BARANOF INTERBAY STORAGE

DRB Recommendation Package #2

West Design Review Board: Meeting Date 08/31/2016

DPD PROJECT # 3022095

4.0 LANDSCAPING

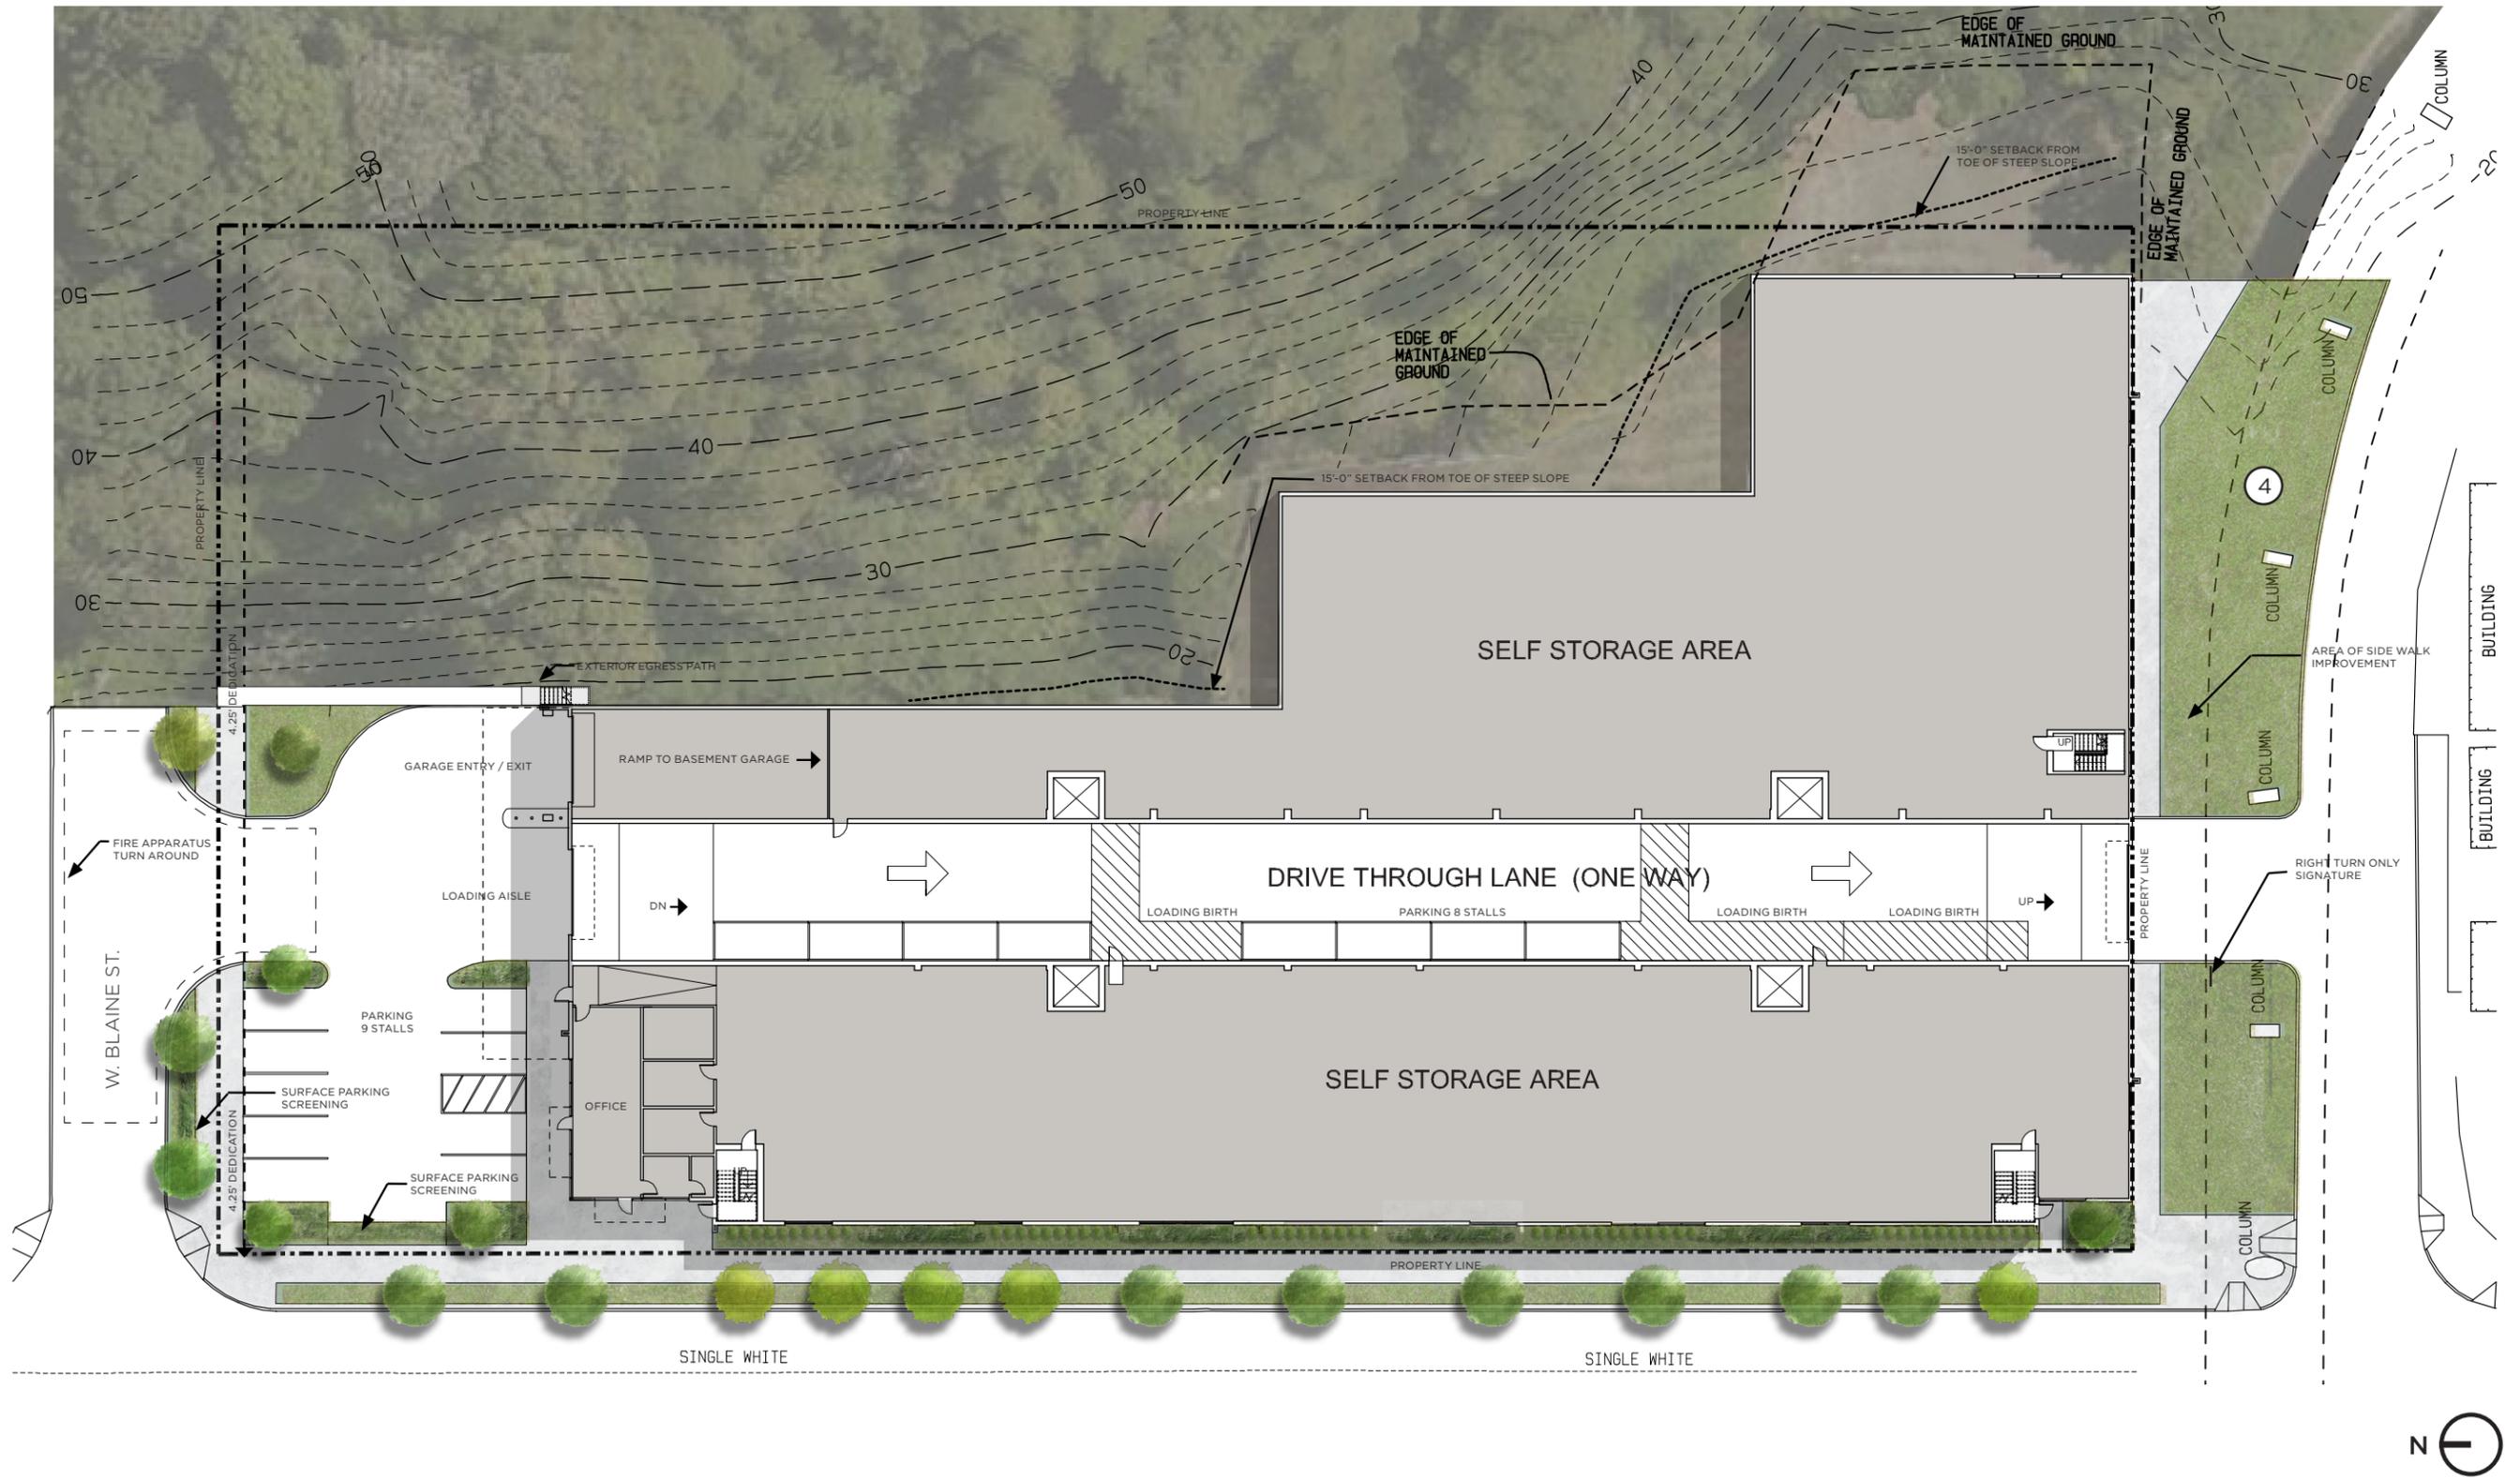
a. The Board did not support the proposed Arborvitae and recommended the installation of lush and robust landscaping to provide greater visual interest. The Board suggested vertical plantings, such as Vine Maple or Dogwood trees. The landscape along 15th Ave W should also include a variety of layers and produce seasonal interest. (CS2-A, CS2-B)

b. The Board recommended a continuous planter strip be provided along 15th Ave W rather than the proposed tree grates, and street trees should be planted the length of the 15th Ave W frontage (CS2-A, CS2-B).

Response: The landscaping has been updated per the board's recommendations. Preference has been given to native and/or adaptive species for the site. Specifically along the West elevation of the building, planting has been selected to modulate with the height of the background structure. At the glazed areas, plants have been selected to be shorter to allow the visual connection from interior to exterior to be maintained. At the taller area below the square arches, taller planting able to grow in the narrow landscape strip, specifically Irish Yews, have been selected to provide tall, columnar, plant elements to further reduce the blank wall feel of the elevation

Response: After review with SDOT, a planter strip has been determined viable and is provided as part of the proposed design response.

GLASS TILE

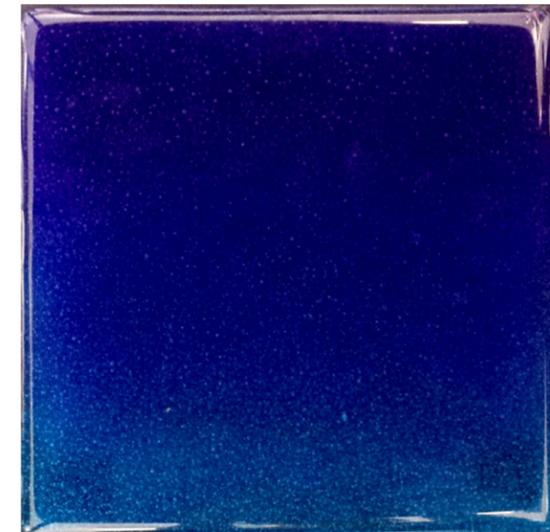
a. The Board supported use of this glass tile and recommended it be used at the office entry due to its small scale (CS3-B, PL3-A).

Response: Glass artwork has been included as part of the entry/office façade design.

Glass tiles from a tenant currently occupying the site will be implemented in the facade adjacent to the office entry to add interest at the pedestrian level at the primary corner of the site.

SITE LIGHTING

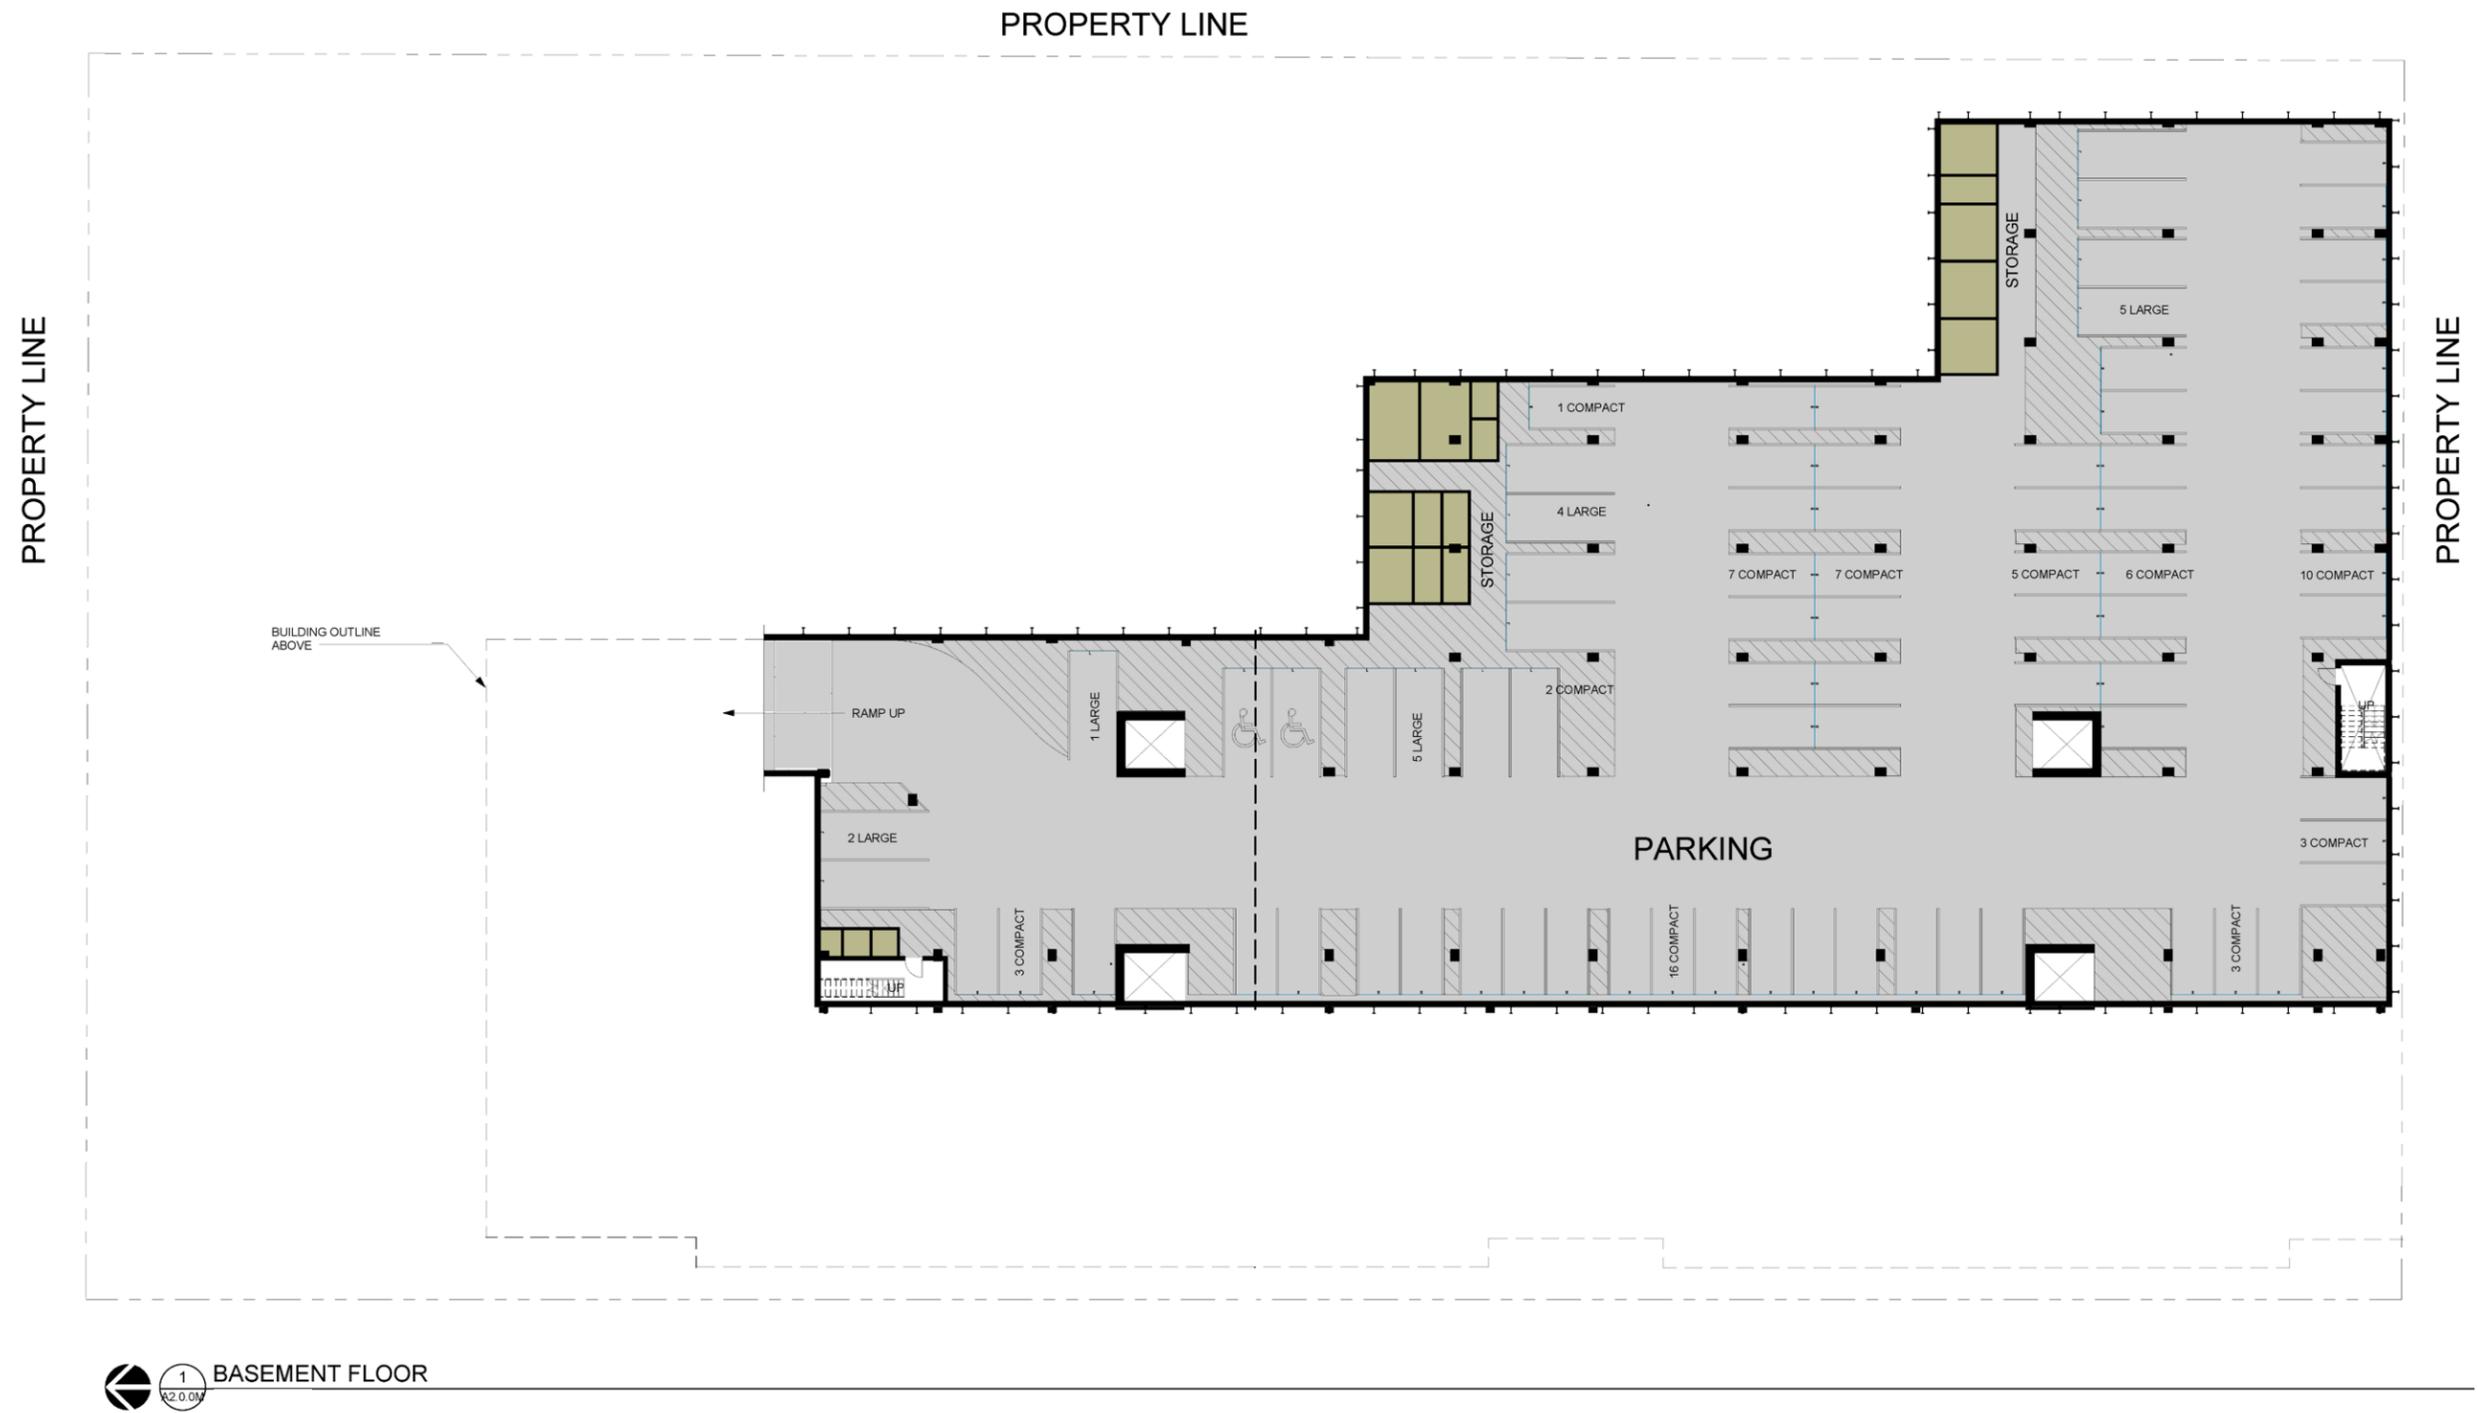
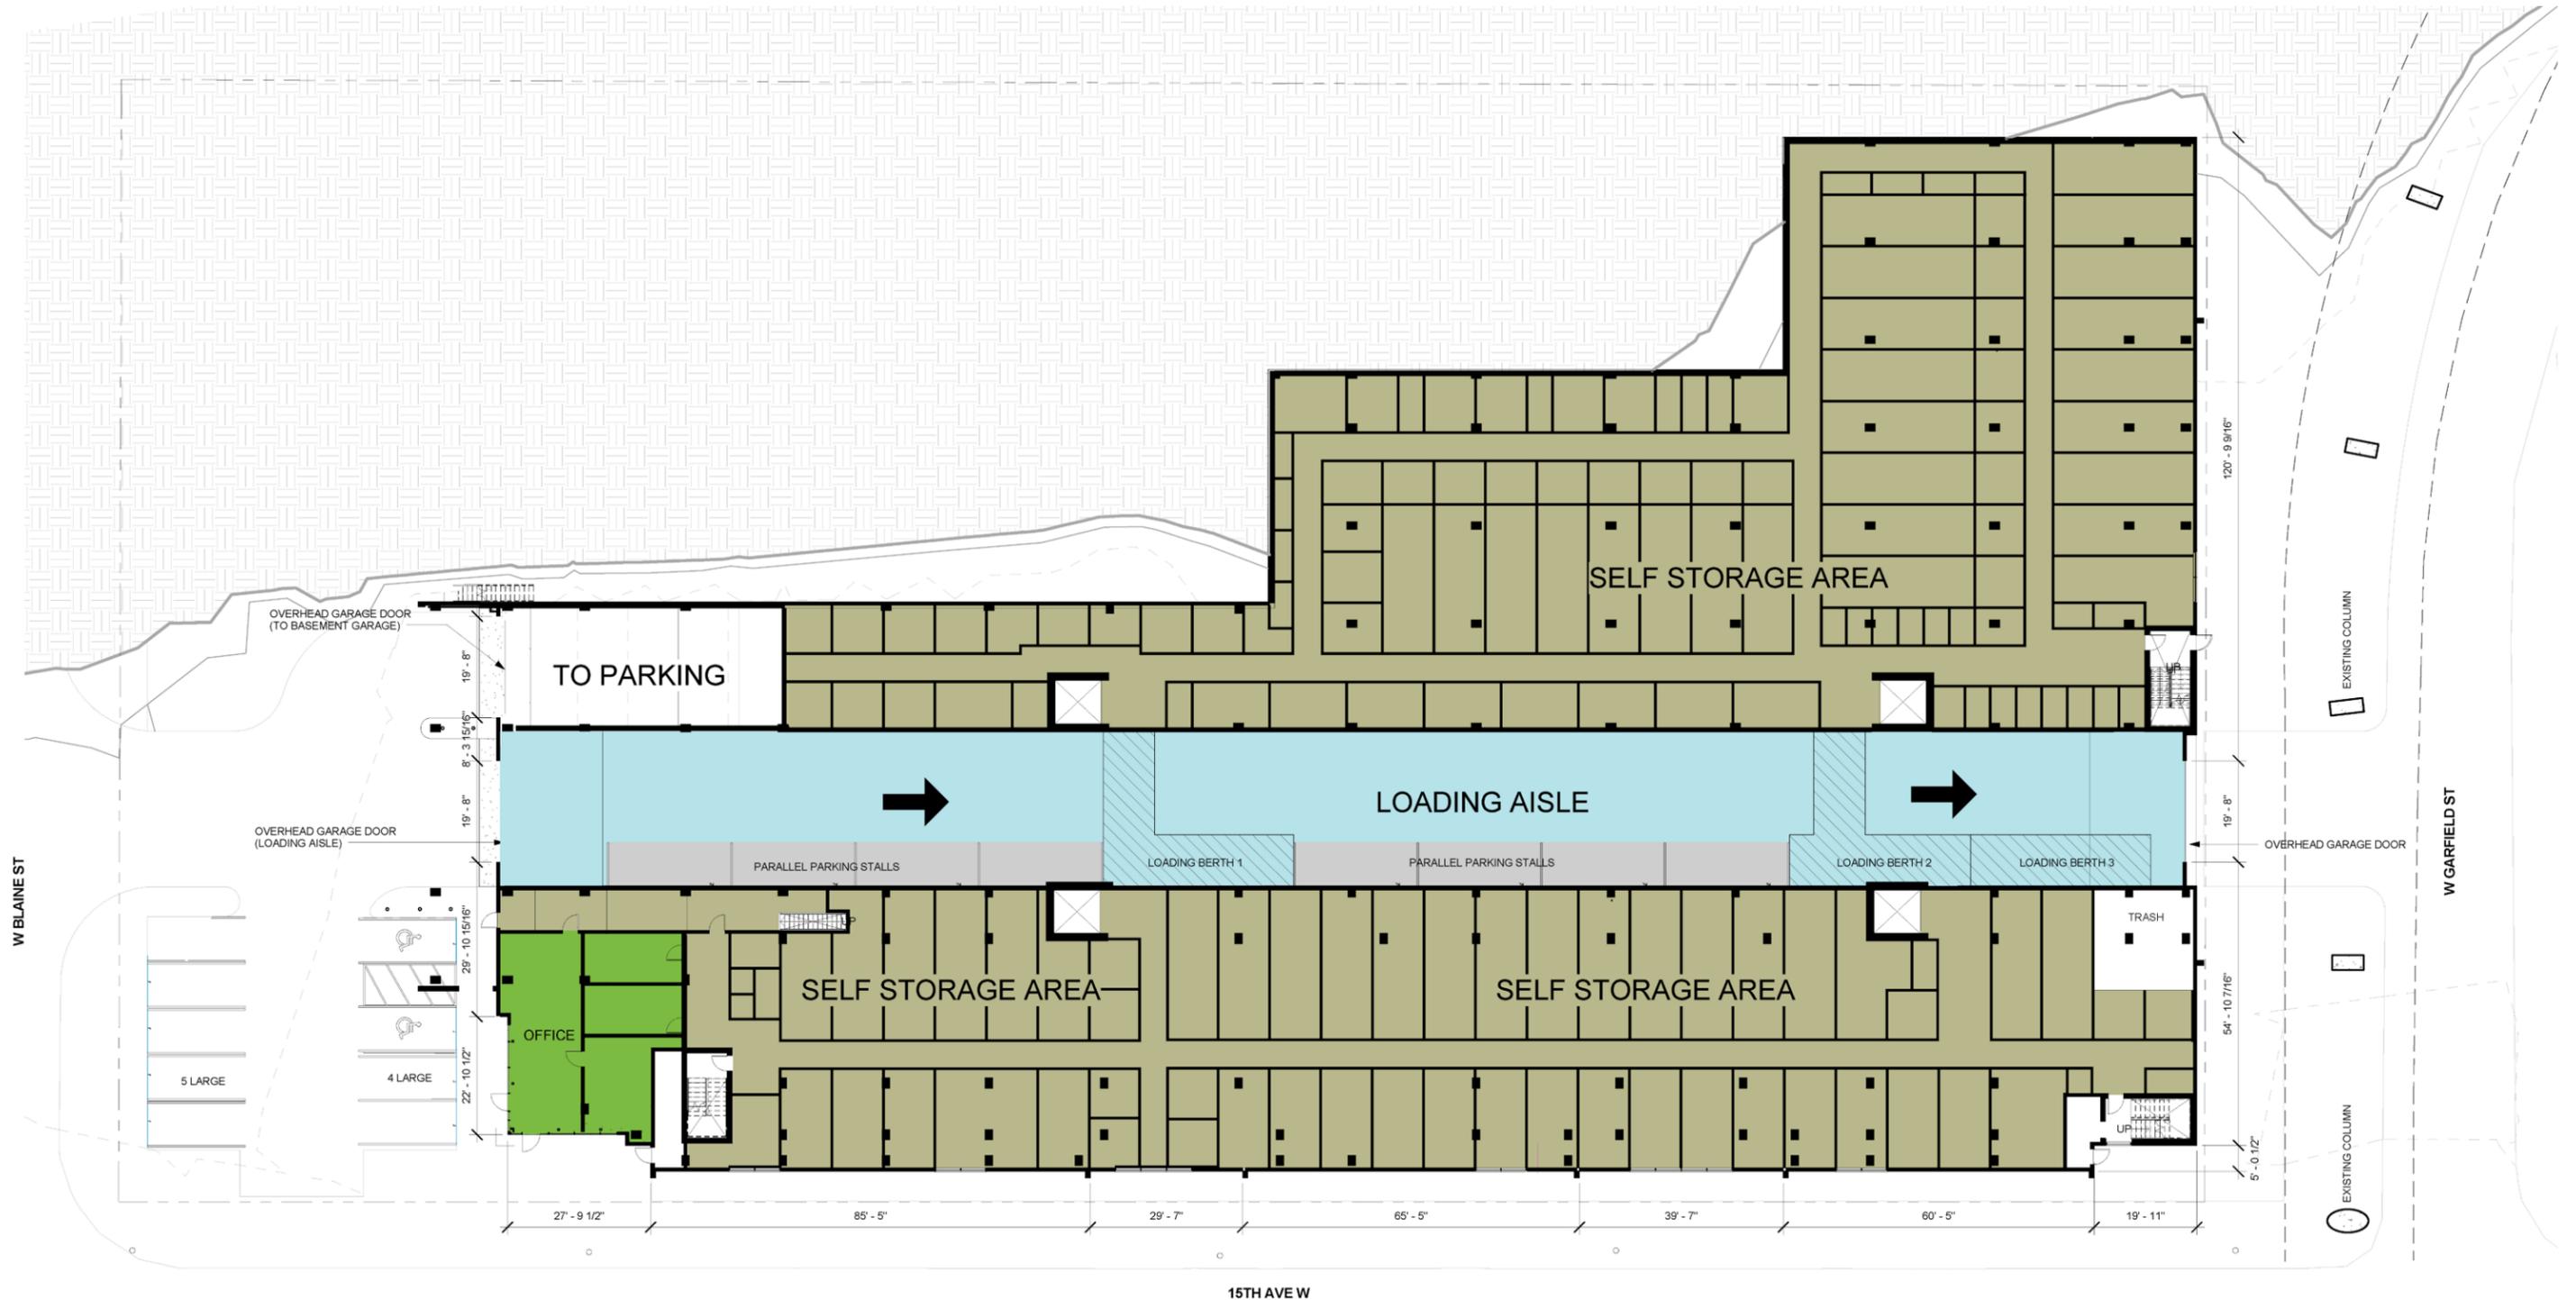
a. The Board expressed concern that there was a lack of lighting along 15th Ave W, and recommended lighting be added to accentuate the architectural concept and/or the artwork on the west façade. The lighting should be of a human scale. (PL2-B, DC4-C)

Response: With the revised west elevation, significant revisions have been made to the lighting to highlight the architecture while maintaining the safety provisions delineated in the original design.
